Access Compliance Report

Public Rights-of-Way

Intersection ID: 31896	Main Street: GREEN_MOUNTAIN_RD	Cross Street: SHOPTON_RD_WEST	Location: SW
ADA ID: 49CD7C82C8D2	Ramp Type: PerpDiag	Initial Pass/Fail: Fail	Overall Compliance: No
Severity Score: 22.5			
Codes/Mitigation Info/Possible Solution		Field Measurements/Component Compliance

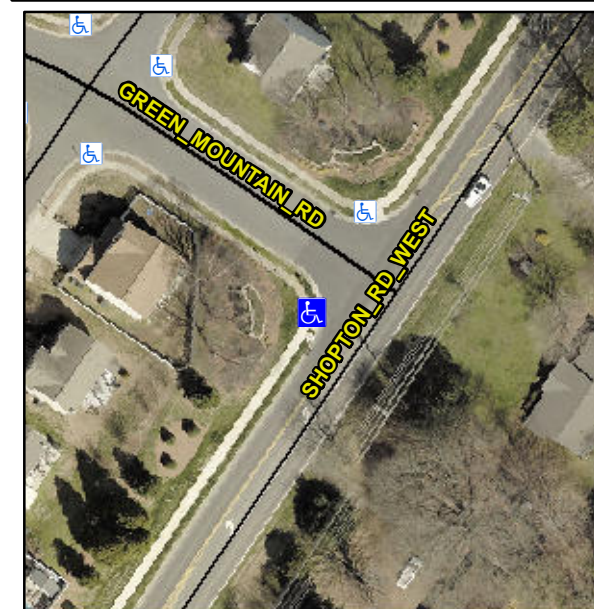
Not Found, R304.5.1, R304.2.2, R304.5.3

Compliance	Description	Data	Compliance	Description	Data
N/A	Ramp Length (in)	47.5	No	Ramp Slope (%)	8.6
No	Ramp Width (in)	47.0	No	Ramp XSlope (%)	3.9
N/A	Flare Type LT	N/A	N/A	Flare Type RT	N/A
N/A	Flare Slope LT (%)	N/A	N/A	Flare Slope RT (%)	N/A
N/A	Flare Traversable LT?	N/A	N/A	Flare Traversable RT?	N/A
N/A	Landing Length (in)	N/A	N/A	DWS Provided?	N/A
N/A	Landing Width (in)	N/A	N/A	DWS Contrast?	N/A
N/A	Landing Slope (%)	N/A	N/A	DWS Length (in)	N/A
N/A	Landing X Slope (%)	N/A	N/A	DWS Full Width?	N/A
N/A	Landing Curb? (Y/N)	N/A	N/A	DWS Offset (in)	N/A
N/A	Shared Landing?	N/A			
N/A	Gutter Ponding?	N/A	N/A	Gutter Slope (%)	N/A
N/A	Gutter Lip Ht (in)	N/A	N/A	Gutter X Slope (%)	N/A
N/A	Painted X Walk1?	No	N/A	Painted X Walk2?	No
	X Walk 1 Direction	To SE		X Walk 2 Direction	To NE
N/A	X Walk 1 Width (in)	N/A	N/A	X Walk 2 Width (in)	N/A
	X Walk 1 Slope (%)	0.3		X Walk 2 Slope (%)	0.8
	X Walk 1 X Slope (%)	3.7		X Walk 2 X Slope (%)	1.3

Remove & Replace Curb Ramp With Two New Directional Ramps or Equivalent.
